SANTA FE COUNTY
IFB NO. 2025-0161-PW/TS
CONSTRUCTION SERVICES FOR
ARROYO HONDO TRAIL SEGMENTS #2 & #3
ADDENDUM NO. 2

QUESTIONS/ANSWERS:

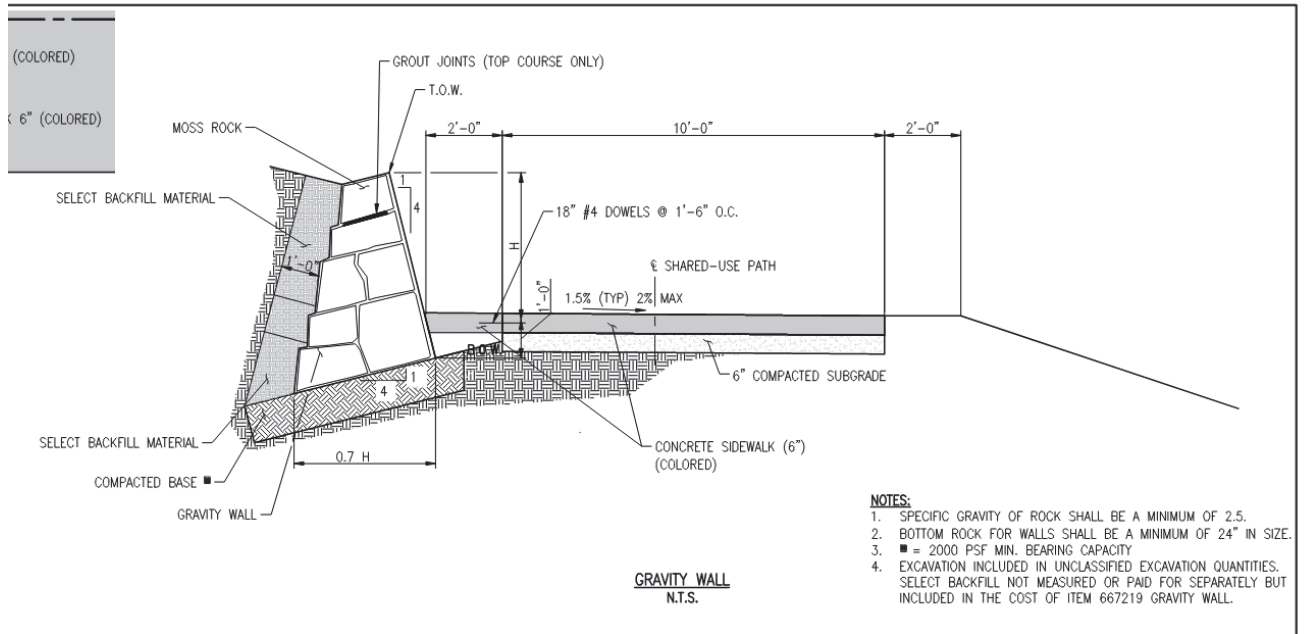
5. Page 62 shows what it appears to be 24" Striping going across the road, along with Yield Striping. Can you add quantity items for this work?

Answer:

- Crosswalk Striping – 60 LF - Item 704704 – Hot Thermoplastic Pavement Markings 24"
- Yield Striping Triangles – 20 LF – Item 704728 - Hot Thermoplastic Pavement Marking Yield Line
